Service Advisory

MTD-043

(Hand Held String Trimmer)

Subject: **MANDATORY REPAIR** - Potential safety concern arising from the potential loss of the shield mounted trimmer blade during operation. The Troy-Bilt string trimmer models listed in "**Models Affected**" within the "**Serial Number Range Affected**" may have suspect shields.

FIGURE 1

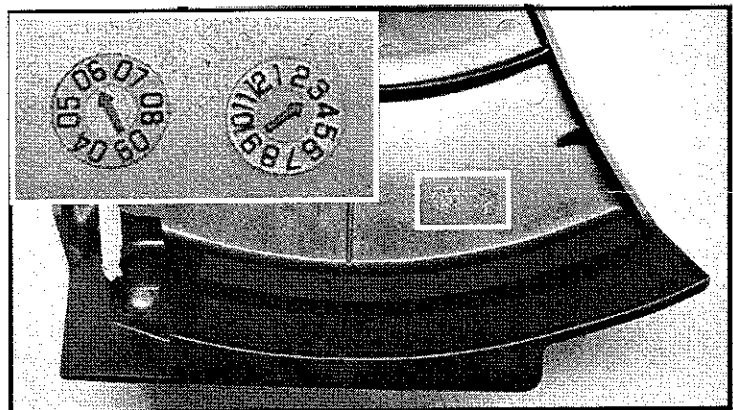
- To read the mold date refer to Figure 1. The mold date clock on the left, see inset, is the "mold year" (last two digits of the year). The mold date clock on the right, see inset, is the "mold month".
- Determine the shield's "mold date" by reading the right hand clock then the left hand clock. The mold date for the shield in Figure 1 is "03/06" (March 2006).
- Suspect shields have mold dates of "12/05", "1/06" and "2/06". Determine if the unit has a shield with one of these mold dates.

- Replace any suspect shield assembly with Service Kit **753-05375**.
